A	06.02.2020	ISSUED FOR APPROVAL	
B	20.02.2020	ISSUED FOR APPROVAL	
C	10.06.2020	PATIO SIZE REDUCED FOR APPROVAL	
REV	DATE	DESCRIPTION	
CLIENT			
COLIN GIBSON			
DRAWING TITLE		PLAN AT RL	
PROJECT		LYNDLEY ST, BANKSIA GROVE PATIO	
DRAWN		DL	ISSUE DATE 05.02.2020
JOB NUMBER		DRAWING No	
SCALE		N.T.S.	MP3
			C

REV	DATE	DESCRIPTION
A	14.03.2019	ISSUED FOR APPROVAL
CLIENT		
COLIN GIBSON		
DRAWING TITLE		PLAN AT RL
PROJECT		LYNDLEY ST. BANKSIA GROVE PATIO
DRAWN	DL	ISSUE DATE
JOB NUMBER		DRAWING No
SCALE	N.T.S.	MP1
		A

A	14.03.2019	ISSUED FOR APPROVAL		
REV	DATE	DESCRIPTION		
CLIENT				
COLIN GIBSON				
DRAWING TITLE		3D - VIEW		
PROJECT		LYNDLEY ST. BANKSIA GROVE PATIO		
DRAWN		DL	ISSUE DATE	
JOB NUMBER			DRAWING No	
SCALE		N.T.S.	MD2	A

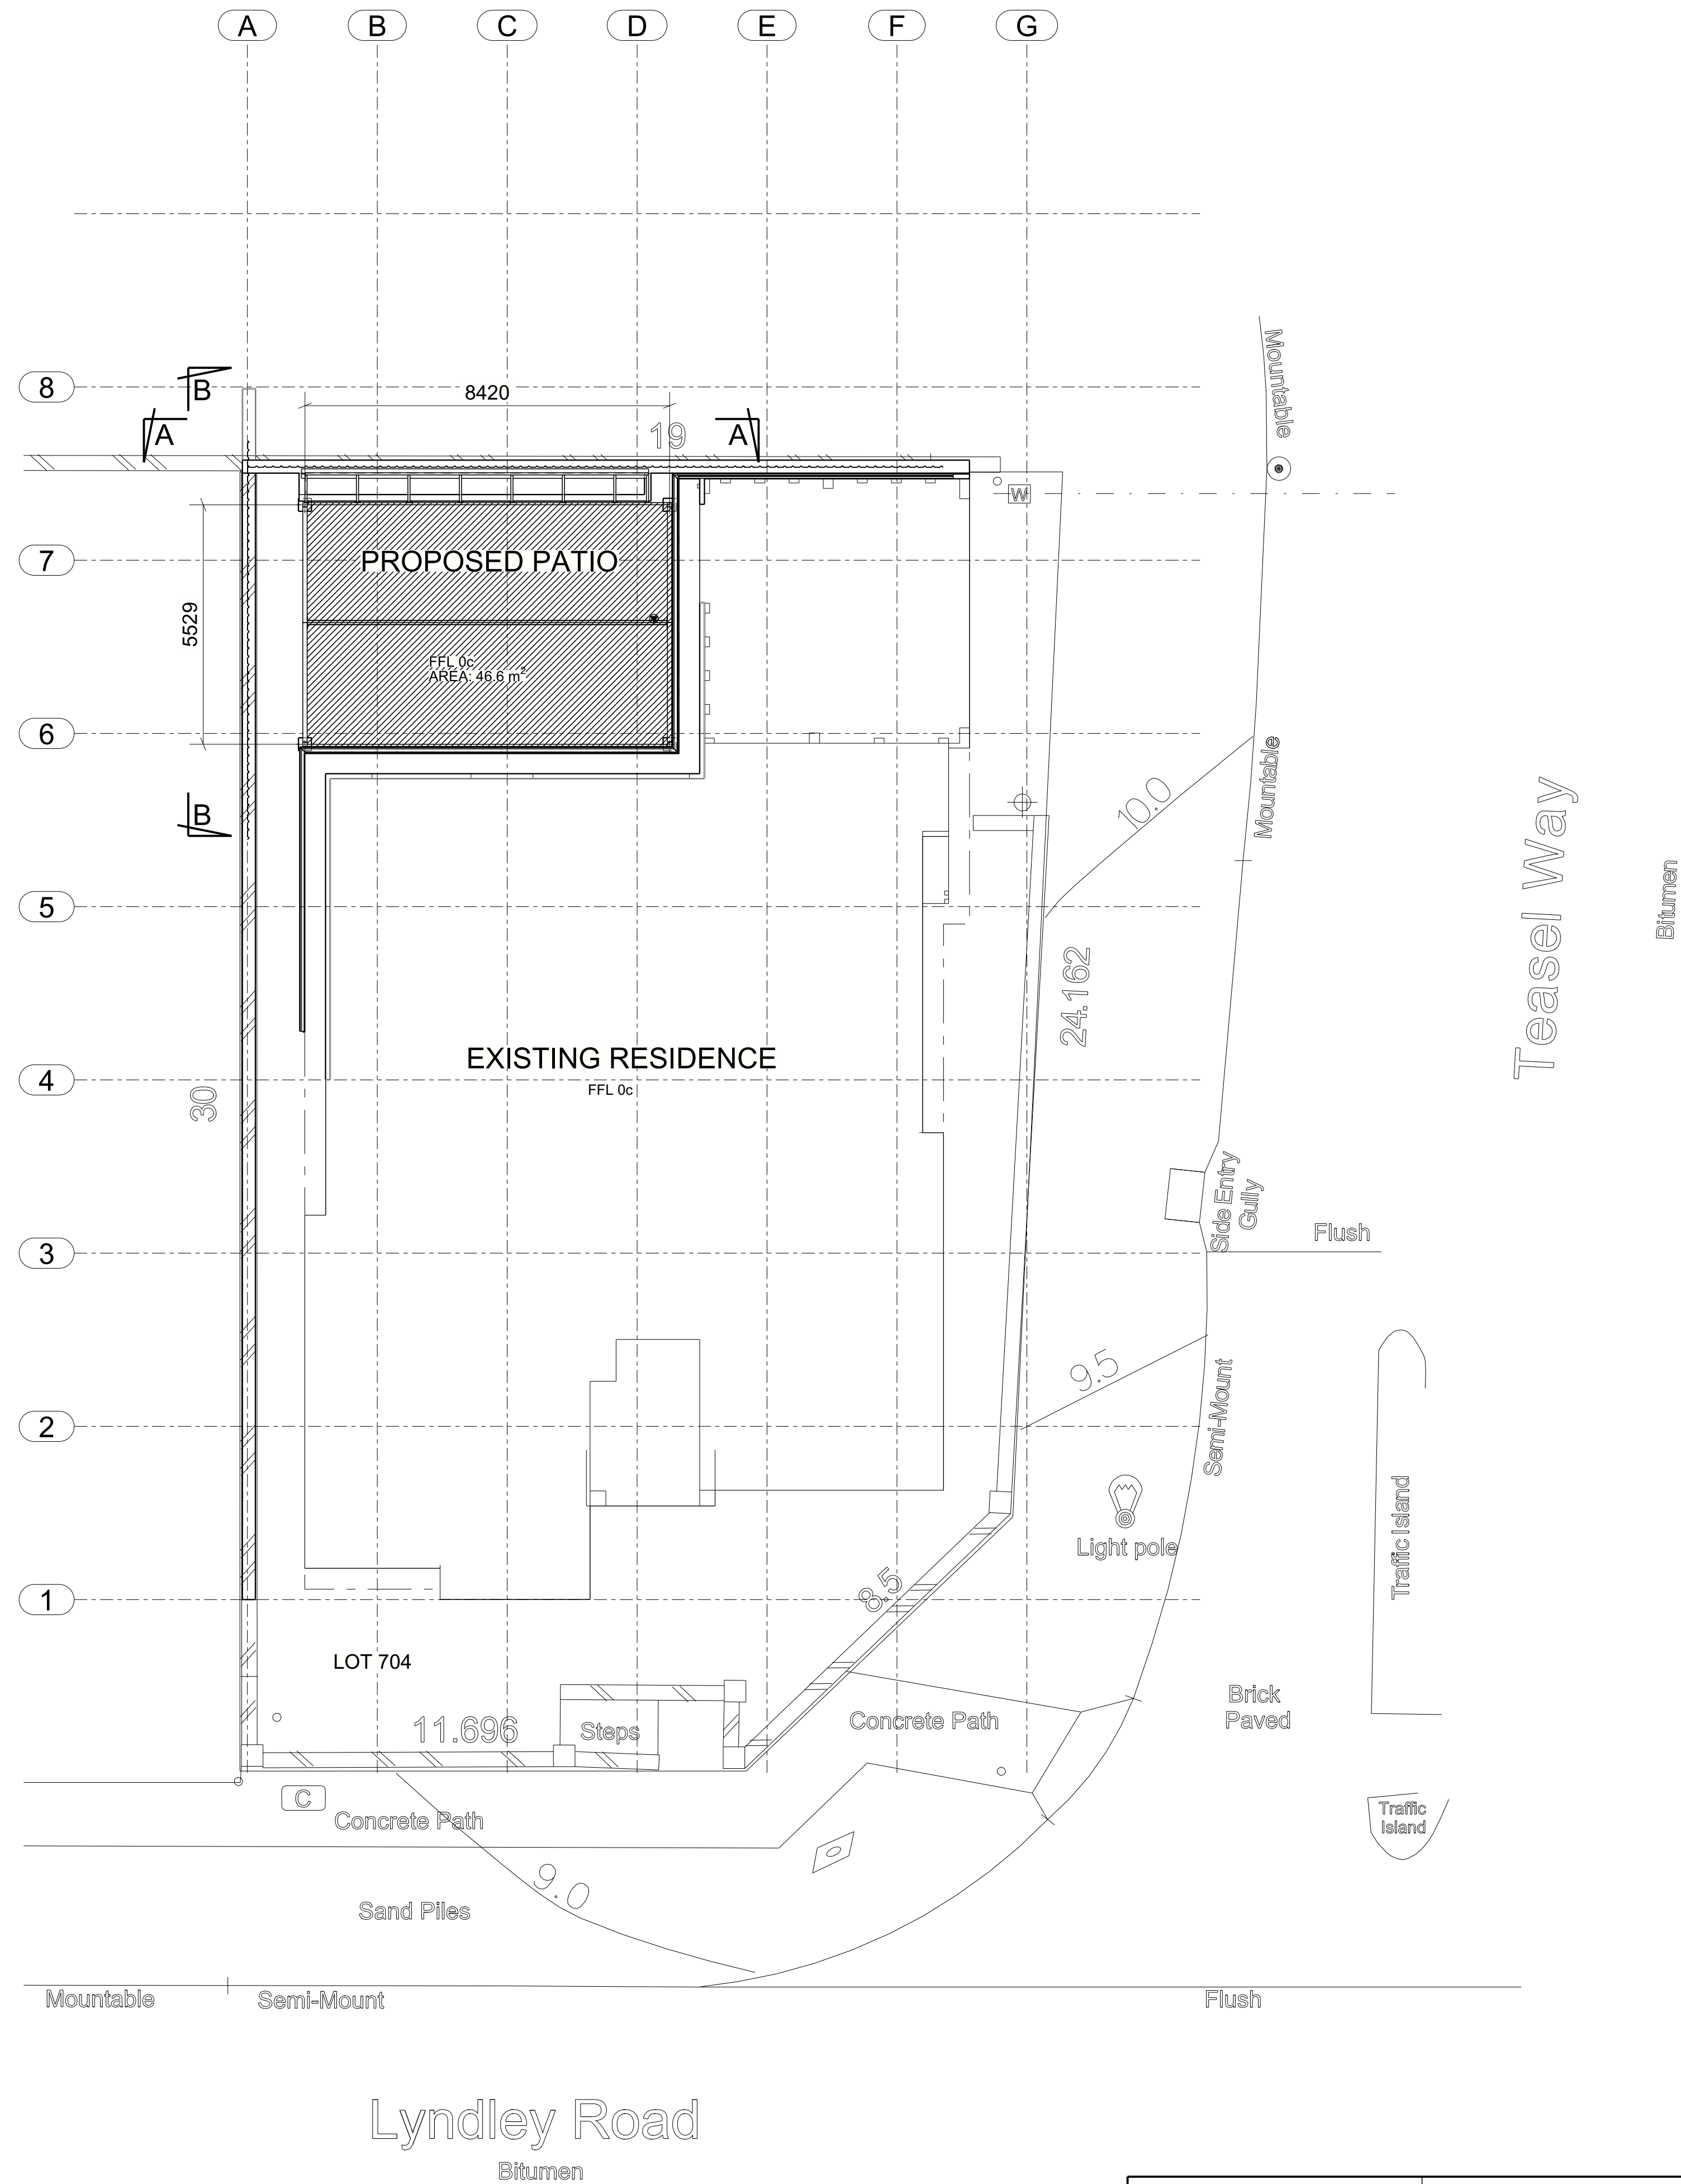
- Modifications - Overall height of patio reduced from 4516 to 4013, a reduction in height of 503
- Truss on northern boundary moved from boundary wall, 1200 south, thus lining up with house

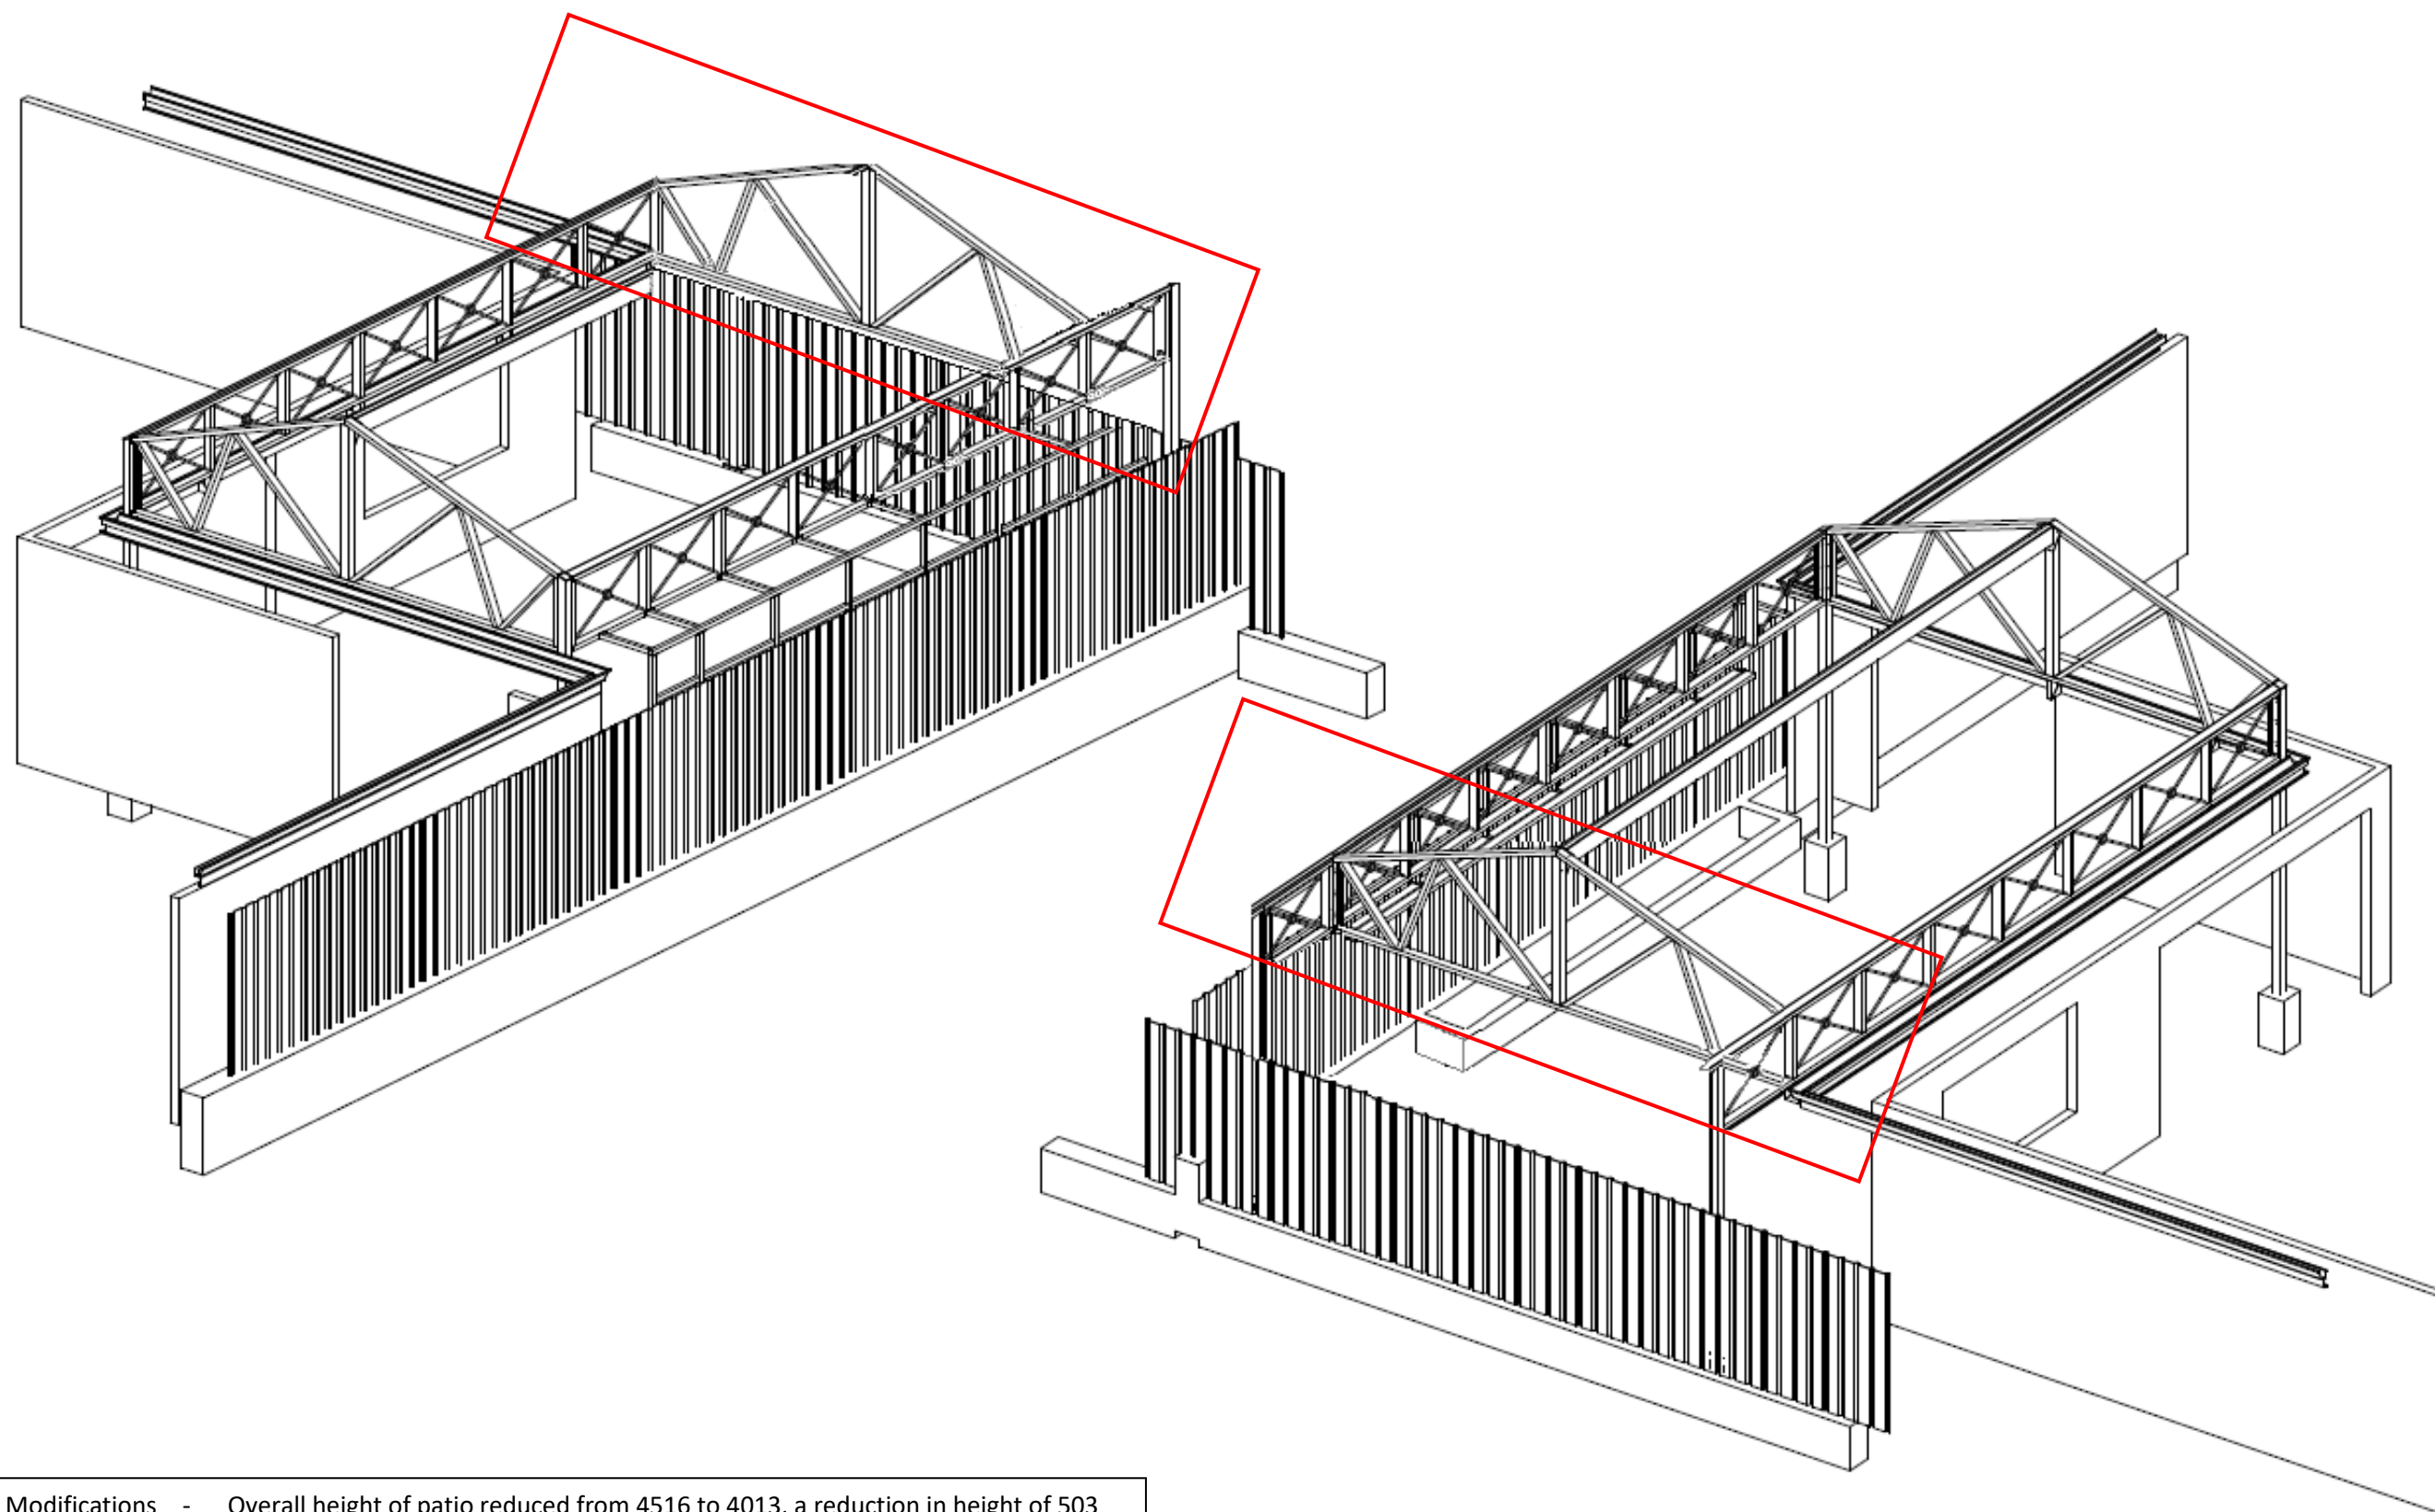
- Modifications
- Overall height of patio reduced from 4516 to 4013, a reduction in height of 503
 - Truss on northern boundary moved from boundary wall, 1200 south, thus lining up with house
